## In-Person Outreach Event and Survey Overview

## Outreach Event – 2/20/2025

# SurveyMonkey Survey

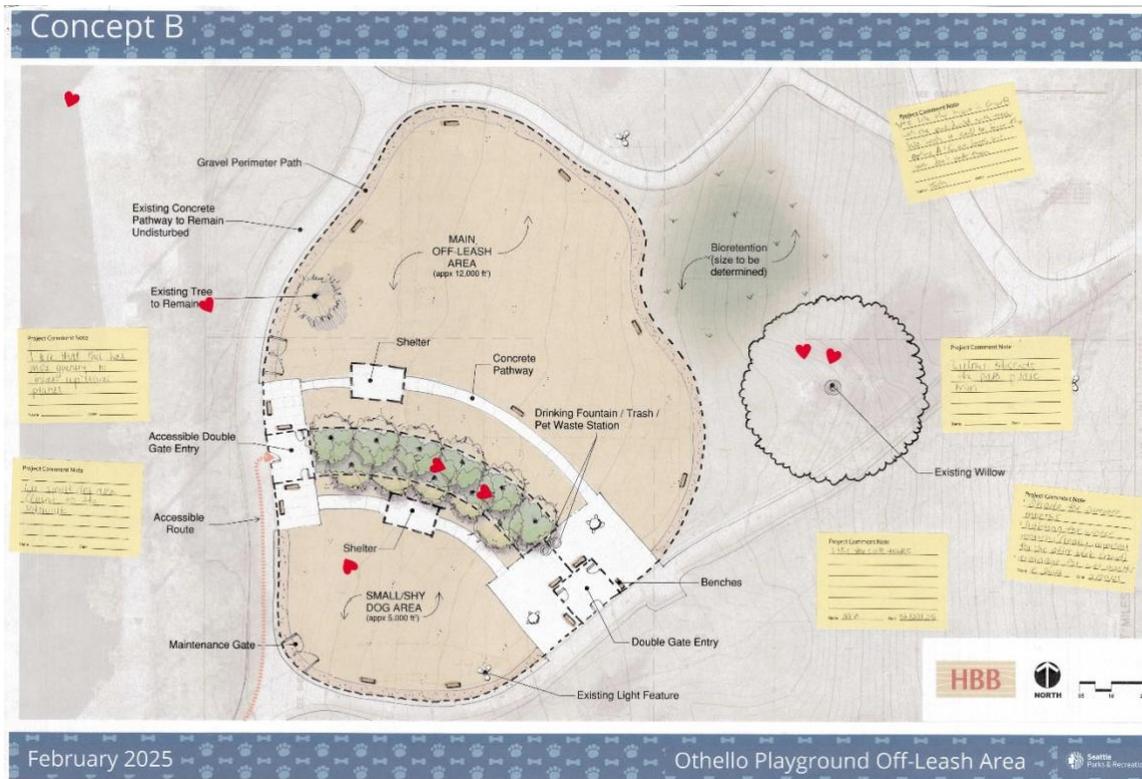
During the in-person outreach event, participants were shown boards with basic project information and the three concepts. They were encouraged to put heart stickers on elements they loved, sticky notes on elements they had feedback on, and to write comments and place them into the comment box. The comments on the sticky notes collected in the comment box are as follows:

- “Add interpretive signage explaining environmental impact of pets: meat consumption, waste disposal, and care”
- “Poop bag dispensers inside and near OLA”

- “More plants surrounding the park to grow and absorb sound. make the small dog area down hill away from residences.”
- “Like wood slat [fence], not chain link. want sound buffer. more vegetation around edges. likes new ginkgo trees. want trash on chief sealth trail.”

- “Existing lighting not enough, add more evening lighting. like tables. like concept A shelters.”
- “Concept B, C -- break up larger off leash area with island of landscaping in the middle.”

- “All options - demonstration project for composting pet waste, perhaps integrate with bioretention?”
- “All options - more landscaping/planting perimeter hedgerow and some full size trees (need protection)”

- “Adding benches along tree line -- concept B”
- “Parking seems to be limited, so please consider bicycle racks to help more people into the park.”
- “They all look good. a few details to think about:

1. add in something that turns people to the view to mt. rainier - spectacular!!
  2. maybe orient some paths to that view - per site location map.
  3. i prefer the curved paths up top than the dog area. given the gentle hill and landform.

4. really great that you followed the hill so that the area for dog park is specifically delineated and the rest of the park is separate.
  5. just not sure how much formality needs to be added to the hilltop crossings. prefer something more organic given the landform + new... though I'm partial to delineate paths.”

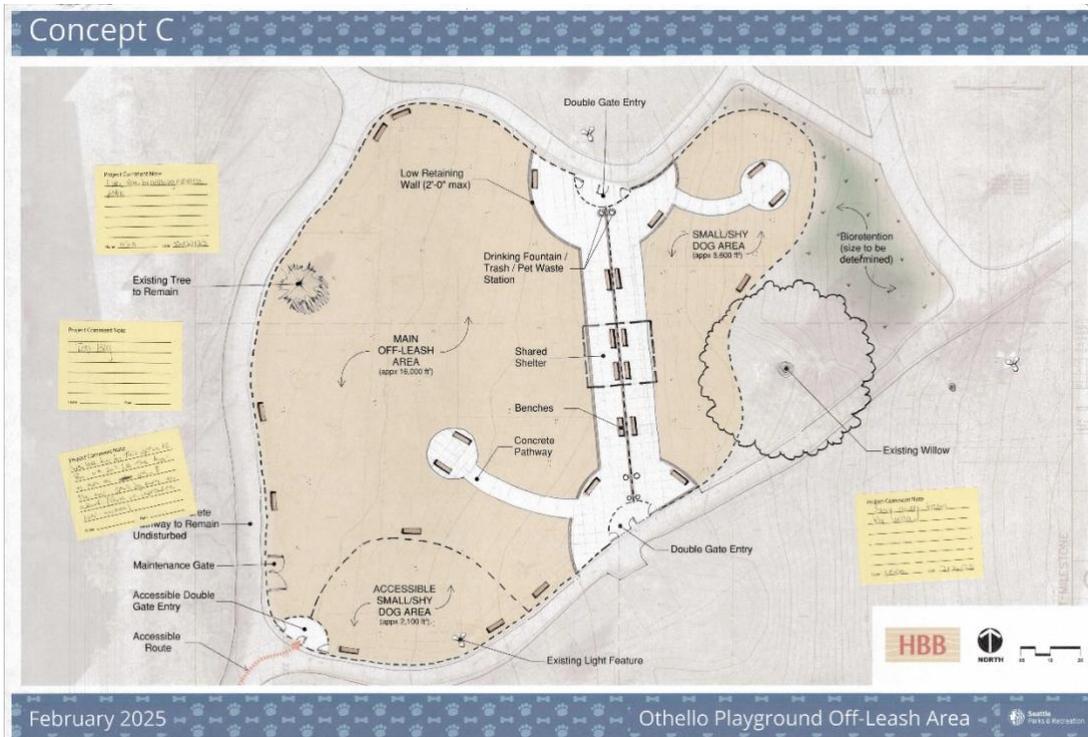
- Concept B
  - “- shade for summer months - lighting for winter months (really important for after work crowd) - drainage for wet months”
  - “We like the layout in concept B with the park divided with trees. we wish it could be bigger. options A+C are larger, but we don't prefer them.”
  - “Willow obstructs the path, please trim”
  - “I like that this has more greenery to break up visual planes.”
  - “Like small dog area closest to sidewalk.”
  - “I like the circle tables”

- Concept C
  - “We love how big this option is. but we don't like the layout as much as option B. the two small dog parks are awkward (though we understand the need for accessible areas)”
  - “I like the branching concrete paths.”
  - “Stay away from the willow”
  - “Too big”

### 3. Is there anything you'd like to be different about these concept options?

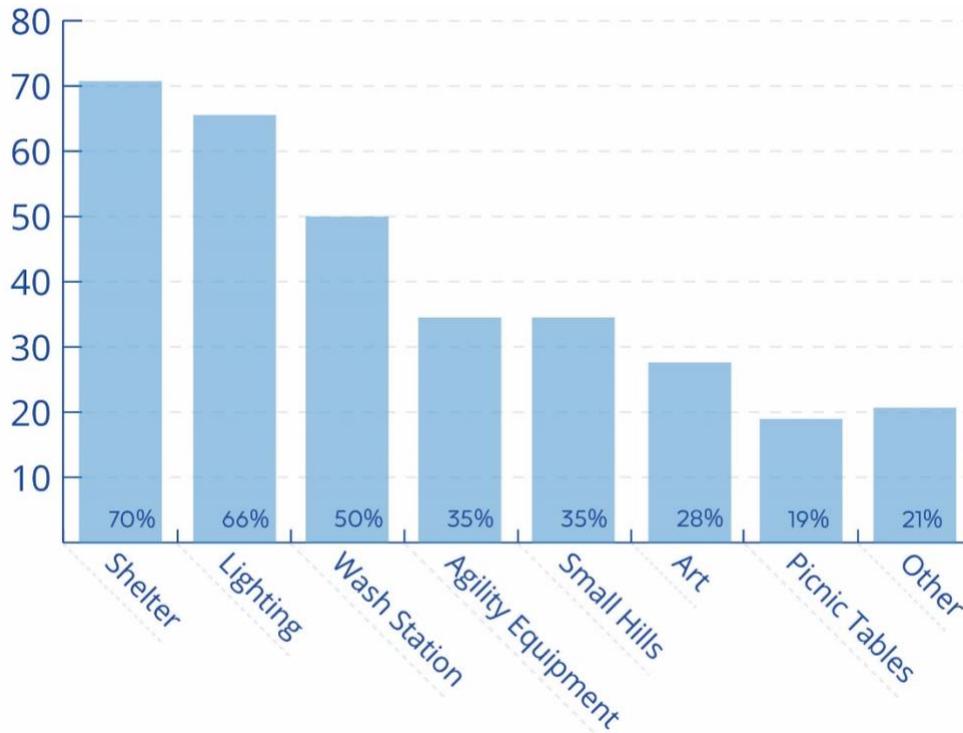
- Answered: 106 / Skipped: 3
- Similar to the past question, the most frequently mentioned item was greenery (8 mentions). People want even more trees than what is proposed.
- There was no other item that was mentioned with such high frequency. With 2 mentions each, folks advocated for more water fountains, a larger footprint, a smaller footprint, and an interior path.

- *"If at all possible could you make a larger park, I realize there's probably limitations but I imagine it would be wildly popular once people realize it's here and it might get pretty crowded fast."*

- *"We need more trees to block out noises especially for the surrounding neighbors."*
- *"In all options, need a larger buffer distance between perimeter fence and existing park walkways. Add a pollinator friendly hedgerow planting buffer adjacent, outside perimeter fence. Reducing the gravel dog run area in favor of buffer landscaping is a win win."*

- *"I don't think it makes sense to have 2 shy dog areas so I don't like Option C"*
- *"I don't like the pathway splitting of the large dog leash area of concept A. I also don't like the shared shelter space of C"*

- *"I wish the small blank area beyond the retention area in B was an outdoor space for cats who use leashes. Cats want outdoor time and it's hard to provide it safely in the city."*

## 5. Is there any other input you'd like to provide for this project?

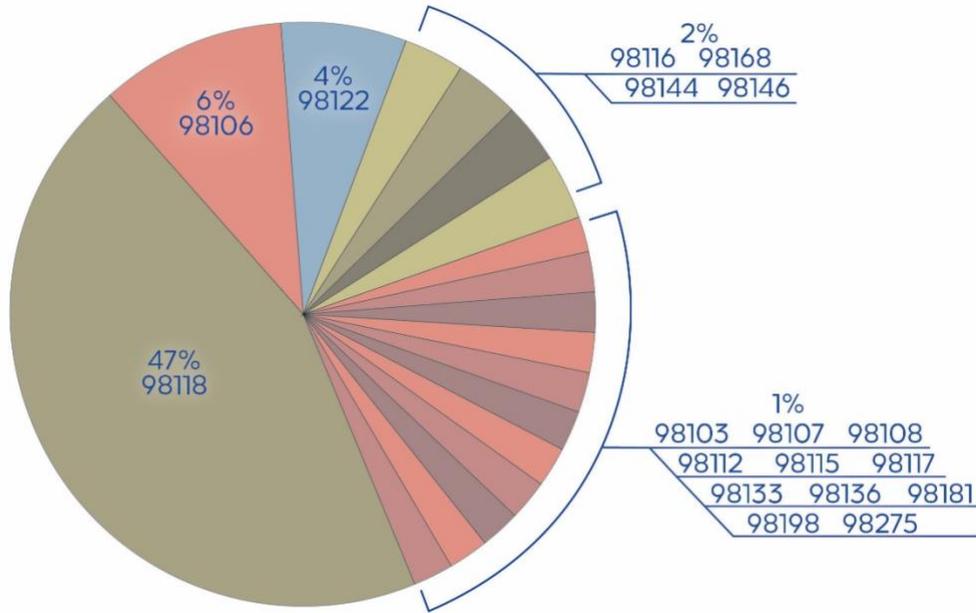
- Answered: 23 / Skipped: 39
- Folks were concerned about the impact of the dog park on the surrounding neighborhood and the existing park usage. They advocated for sufficient fencing and buffers.

- *“Please limit the amount of mud or provide drainage for increased use in the rainy months”*
- *“Have trash cans integrated into fencing so they can be emptied from the outside of the park.”*
- *“As someone who's kids utilize the area around the willow tree frequently and see other kids there as well, option C feels a bit more invasive of the already used park space. We live within walking distance and use the park regularly throughout the year. The upper area where the majority of design's are planned are a mostly unused space in the park, except dogs.”*
- *“Decrease Gravel area in favor of increased buffer landscaping. Include a pilot project demonstrating pet waste composting return interpret of signage, highlighting, benefits, and environmental impacts of pet ownership.”*
- *“Sound remediation is important because of how close the OLA is to many people's homes.”*
